# Product Change Notification - SYST-24TQNM777

**Date:** 25 Aug 2017  
**Product Category:** 16-Bit - Microcontrollers and Digital Signal Controllers  
**Affected CPNs:**    
**Notification subject:** ERRATA - dsPIC33EPXXX(GP/MC/MU)806/810/814 and PIC24EPXXX(GP/GU)810/814 Errata Errata Document Revision  
**Notification text:** SYST-24TQNM777

**Description of Change:** 1) Updated silicon issue 3 (CPU) and 28 (CPU) 2) Added silicon issue 39 (CPU).

## dsPIC33EPXXX(GP/MC/MU)806/810/814 and PIC24EPXXX(GP/GU)810/814 Family Silicon Errata and Data Sheet Clarification

**FIGURE 1: SIMPLIFIED BEHAVIOR**

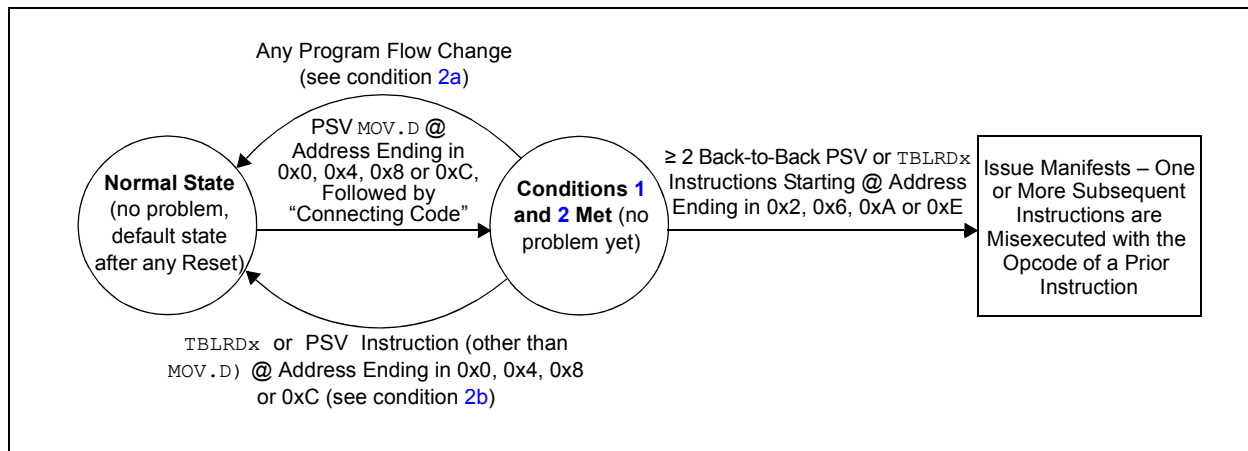
3.	≥ 2 back-to-back PSV or TBLRDx instructions are executed (following the code of condition 2), where the first of the back-to-back instructions is located at an address ending in 0x2, 0x6, 0xA or 0xE.

Figure 1 provides an example of the effective behavior.

1. All instances of PSV `MOV.D` can be replaced with two PSV `MOV` instructions instead. Non-PSV `MOV.D` instructions acting on RAM/SFRs do not need to be modified; or
2. If not already present, a program flow change instruction (such as `BRA $+2`) can be inserted above back-to-back data Flash read sequences; or
3. Back-to-back data Flash read instruction sequences can be broken up by inserting a non-Flash read instruction (such as a `NOB`) in between the Flash read instructions; or
4. The alignment of the code can be shifted to avoid the required opcode location addresses.

C code built with MPLAB® XC16 Compiler, Version 1.32, or later, implements the work around by default. However, if the application uses Assembly language routines, these should be manually modified to implement the work around. Additionally, if precompiled libraries are used, these should be built with XC16 Version 1.32 or later. For additional information, please visit: [www.microchip.com/erratum\\_psrds\\_psrds](http://www.microchip.com/erratum_psrds_psrds).

**FIGURE 16-2: HIGH-SPEED PWM MODULE REGISTER INTERCONNECTION DIAGRAM**

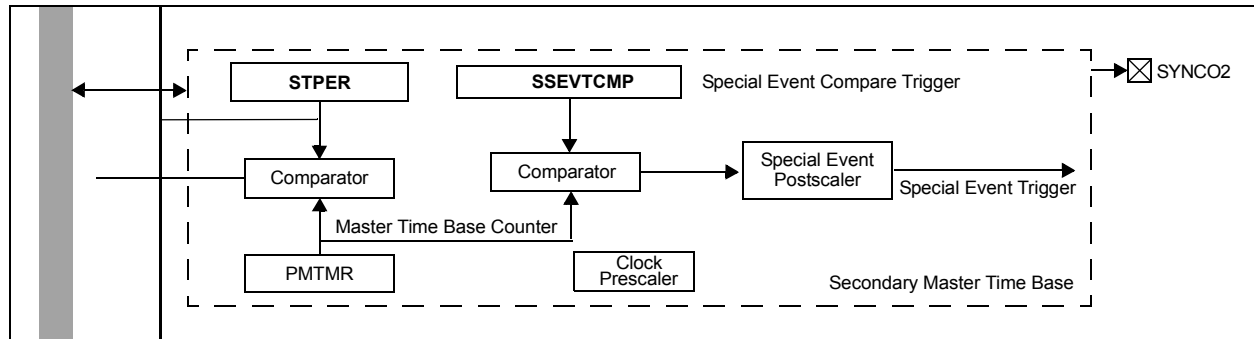
**16. Module: High-Speed PWM Module (dsPIC33EPXXX(MC/MU)8XX Devices Only)**

In **Figure 16-2: High-Speed PWM Module Register Interconnection Diagram**, the Secondary Master Time Base section has been updated. The updated text is shown in **bold** in [Figure 16-2](#) below.
